**ISSUE:** Certificate of Appropriateness for New Construction

**APPLICANT:** Heritage at Old Town PropCo LLC

**LOCATION:** Old and Historic Alexandria District  
431 South Columbus Street, 416 South Alfred Street, 900 Wolfe Street, and  
450 South Patrick Street

**STAFF RECOMMENDATION**

**Figure 8: Revised unit entry stoops**

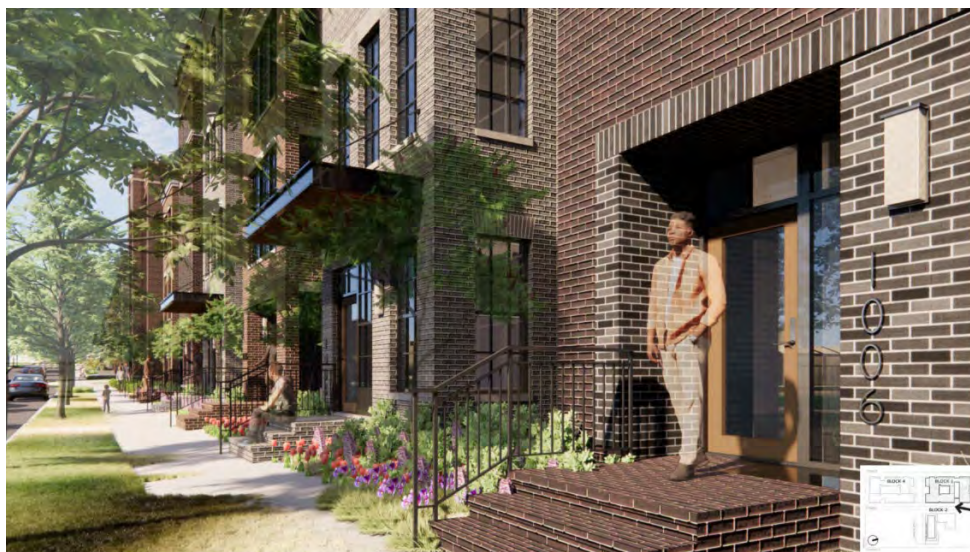
The previous design for the townhomes introduced some variation in the stoop design including some that were recessed and others that used projecting canopies. These revisions remain and the applicant has also revised the stoops themselves to have a variety of widths. Where previously they were all grander in scale, the current design uses narrower stoops to create a more intimate setting (Figure 8).

# BLOCK 1

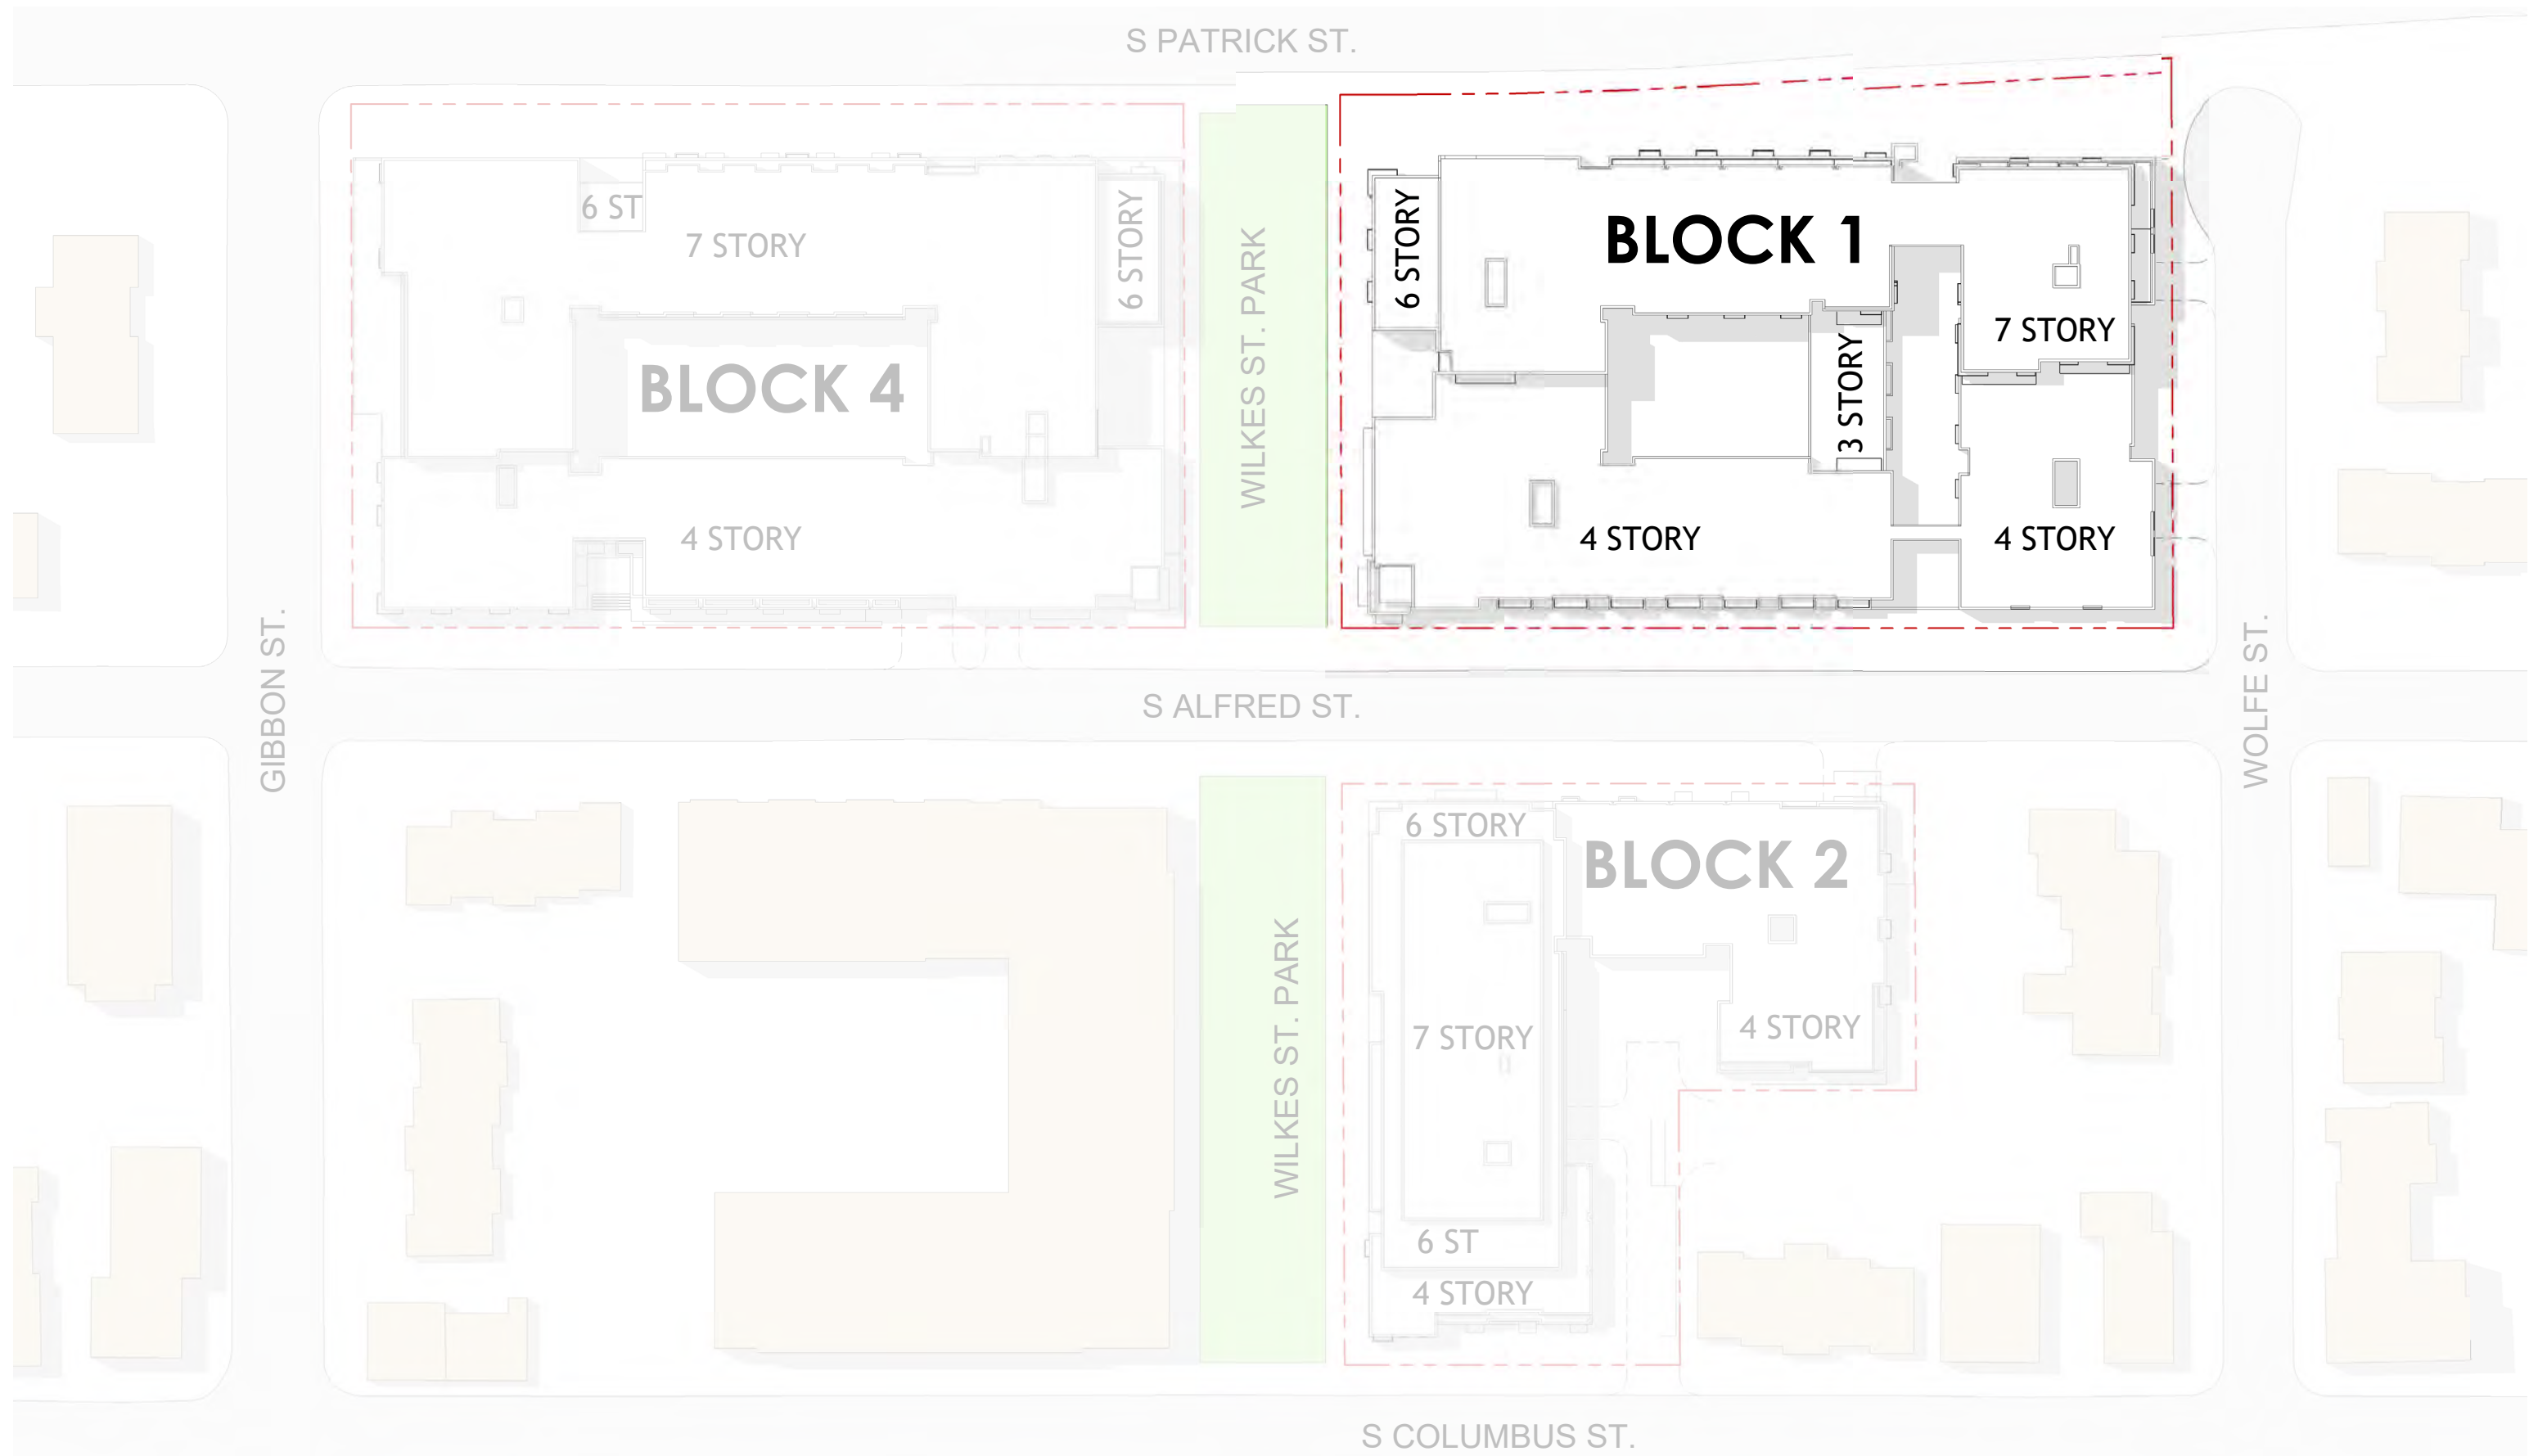
1 - REFINED THE CORNER ENTRY ARCHITECTURE AT S. ALFRED AND WILKES STREET PARK TO ENHANCE THE ART DECO DESIGN -- PROPOSED INTERPRETIVE ART DECO CANOPY DESIGN WITH PATTERNING INSPIRED FROM ART FORMS REFERENCED WITHIN THE HISTORY OF THE SITE.

2 - REFINED THE S. ALFRED STREET TOWNHOUSE FACADES -- CREATED VARIATIONS IN DETAILING, WINDOW TYPES, AND STOOP ENTRIES.

# BLOCK 2

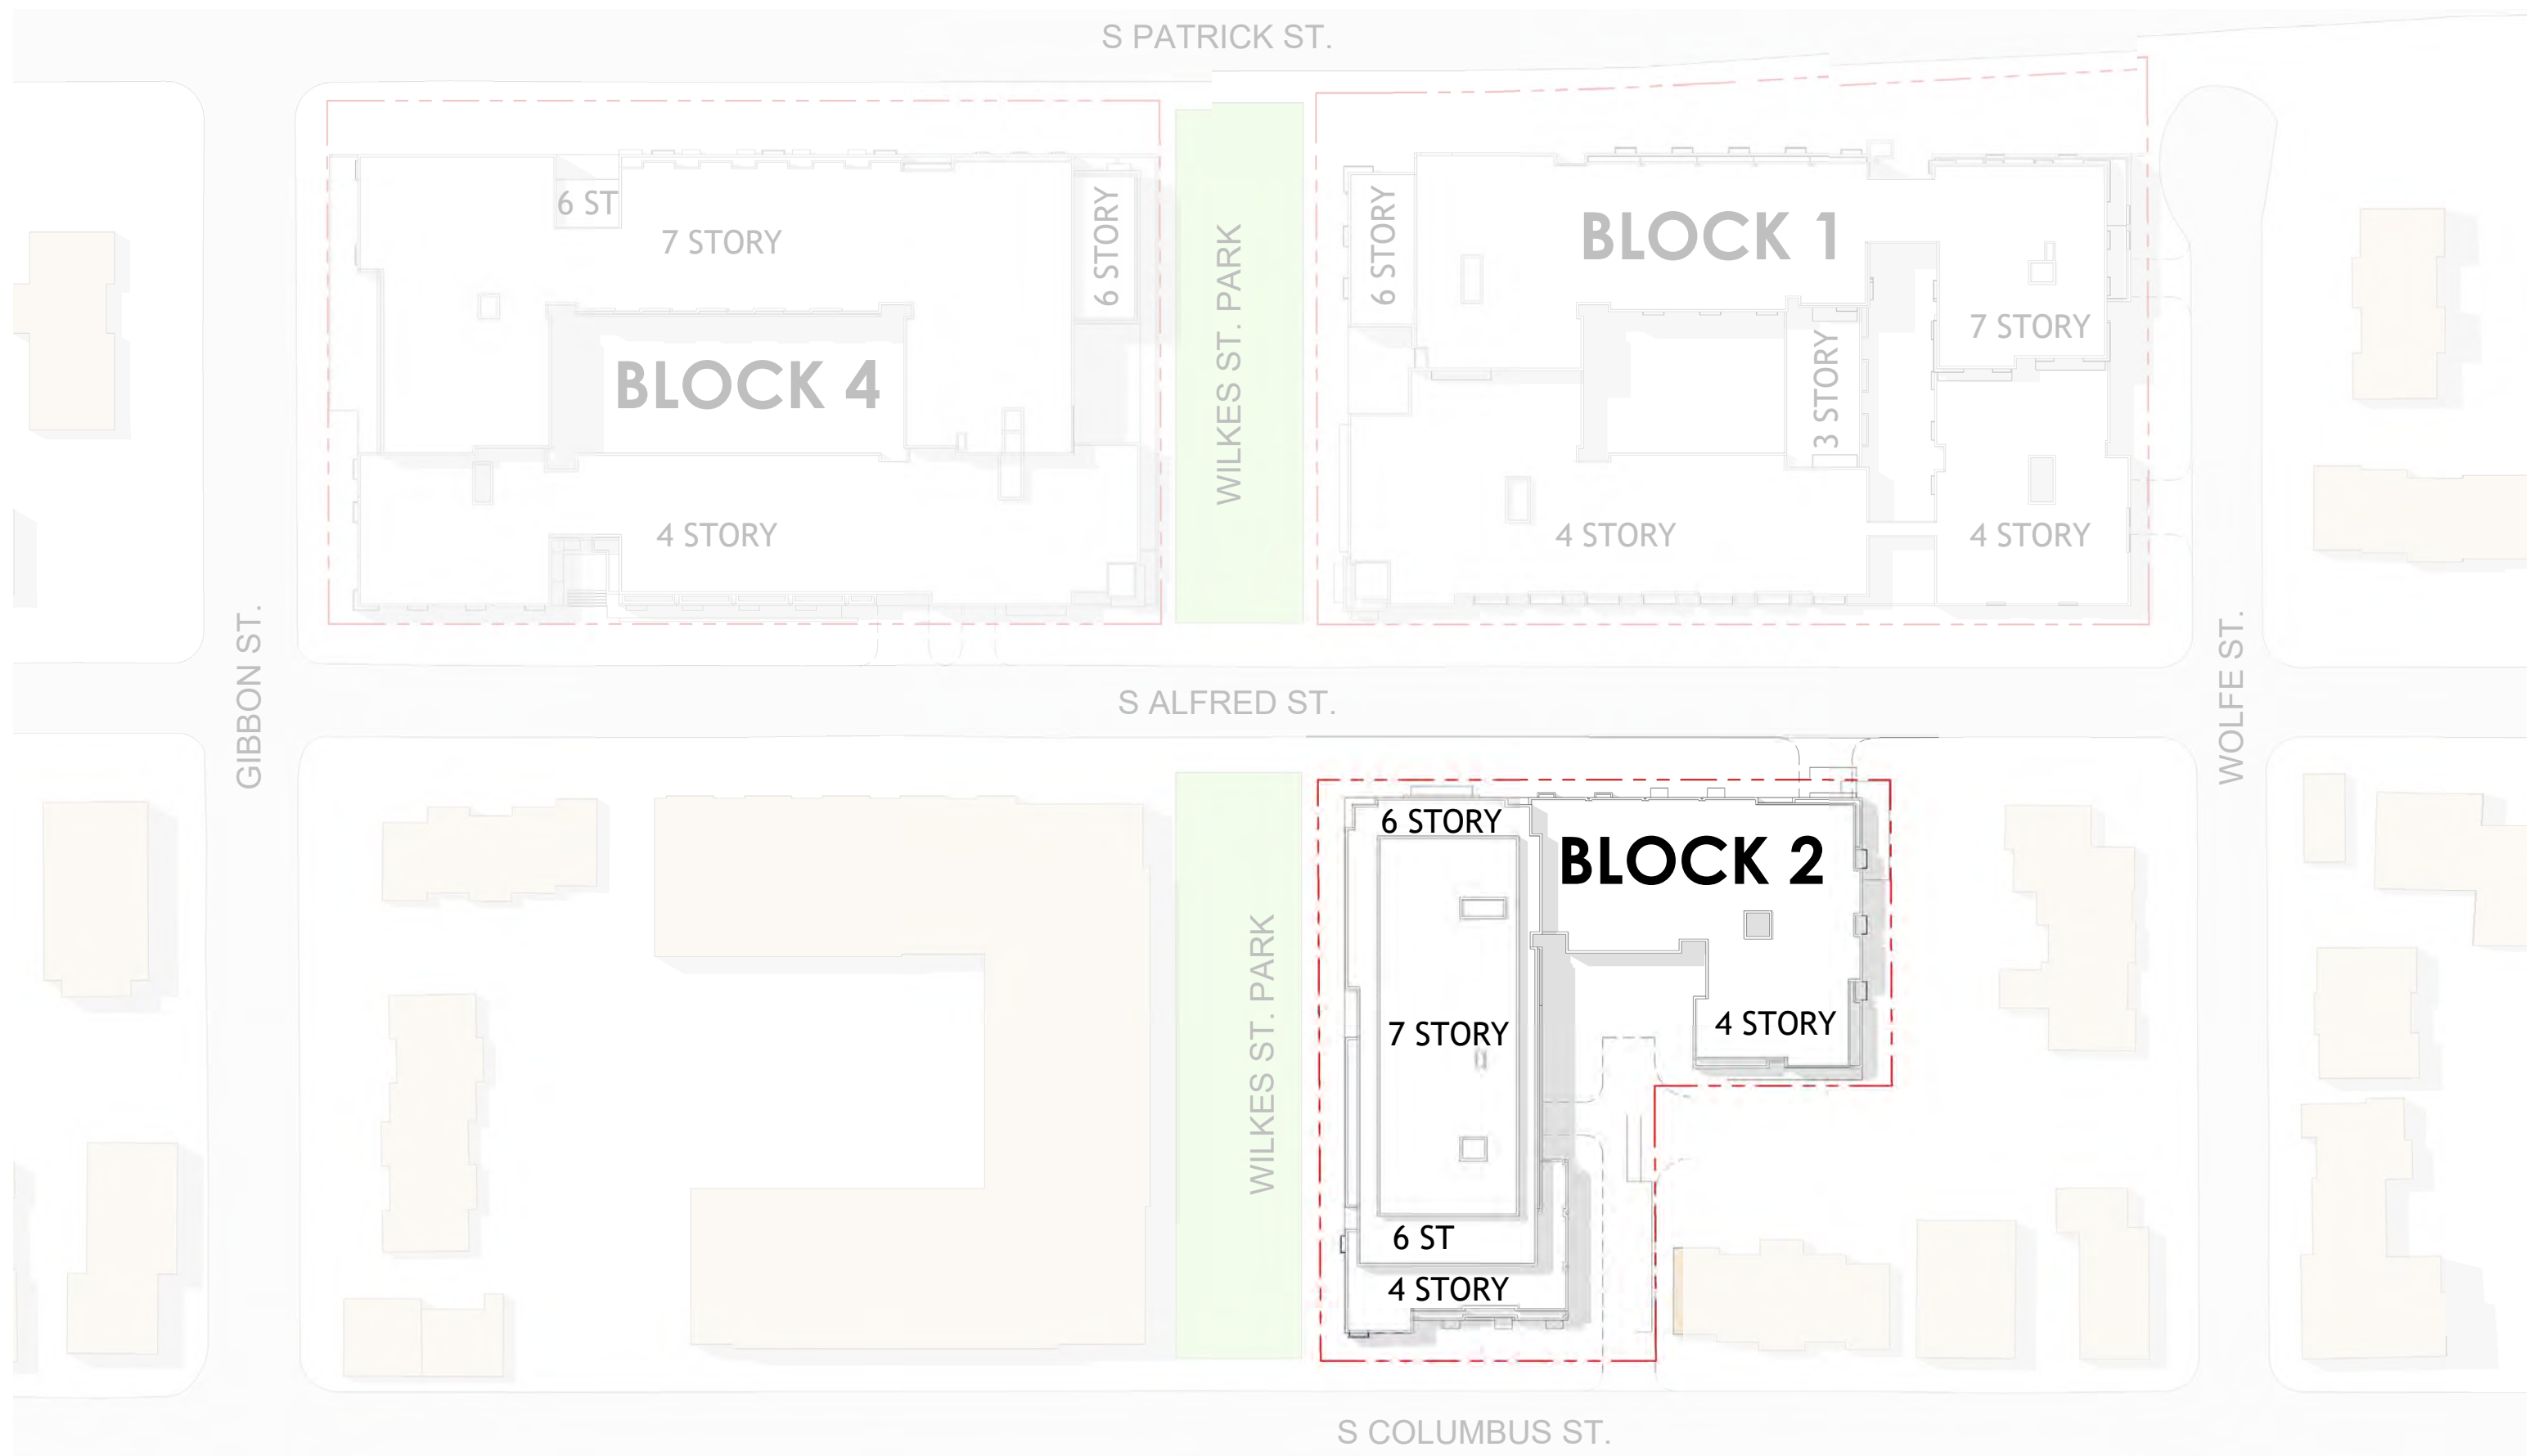
1 - REVISED THE CORNER BUILDING AT S. ALFRED & WILKES ST. PARK -- ADDED DETAILING, UPDATED CORNER BAY ELEMENT, AND REPLACED METAL PANEL ON CORNER OF BAY ELEMENT WITH MORE FAMILIAR BRICK MATERIAL.

2 - UPDATED TOWNHOUSE FACADES ALONG S. ALFRED STREET -- REVISED BRICK DETAILING, WINDOW TYPES, WALK UP ENTRIES AND PROJECTED BAYS.

3 - UPDATED TOWNHOUSE FACADES ALONG S. COLUMBUS STREET -- UPDATED CHARACTER TO BE MORE CONTEXTUAL WITH PITCHED ROOF LINES, DORMERS, AND TRADITIONAL UNIT ENTRY SURROUNDS.

4 - REVISED SIX-STORY FACADE ON WILKES ST. PARK -- INTRODUCED A NEW BUILDING TYPE TO REDUCE SENSE OF SCALE, UPDATED MASSING, AND BUILDING BASE ELEMENT.

5 - ADDED VARIATION TO BRICK DETAILING AND WINDOW TYPES THROUGHOUT.

HERITAGE VOID TO SOLID MATRIX - BLOCK 1

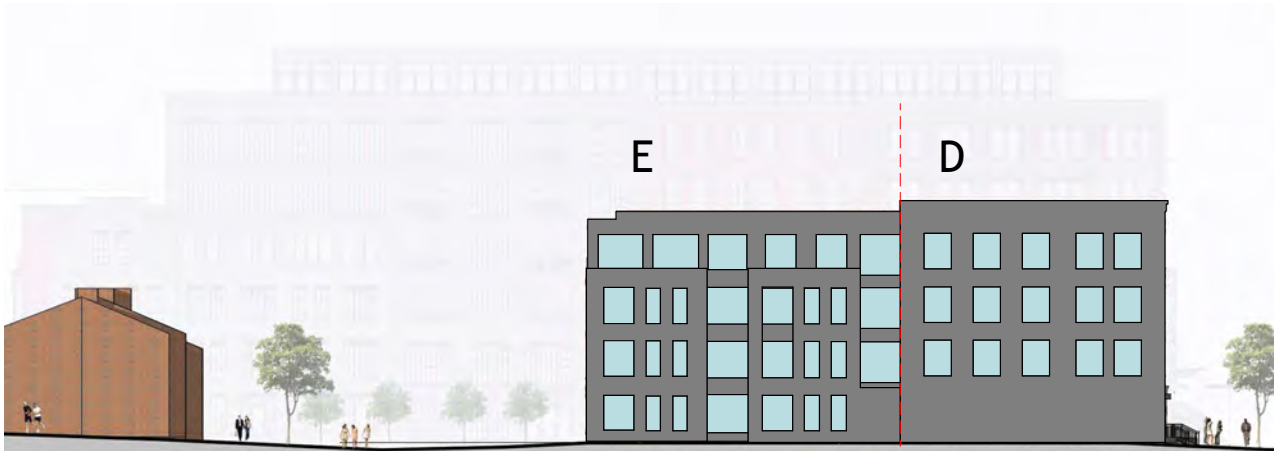
In response to a request from the Board, the applicant has prepared an exhibit that breaks down the solid to void ratio for each of the building elevations. The provided ratios vary depending on the relative portion of the building, but generally they range from 51% to 81% solid. The solid to void ratio of historic buildings depends upon the specific style that is being referenced, with some architectural styles featuring larger windows than others. In general terms, residential buildings tend to have a higher ratio of solid to void area than commercial or retail buildings. When comparing historic buildings to modern buildings, the proportions of the proposed window openings and their relation to the overall elevation and to other features on the elevation is an informative method to weigh compatibility between the structures.
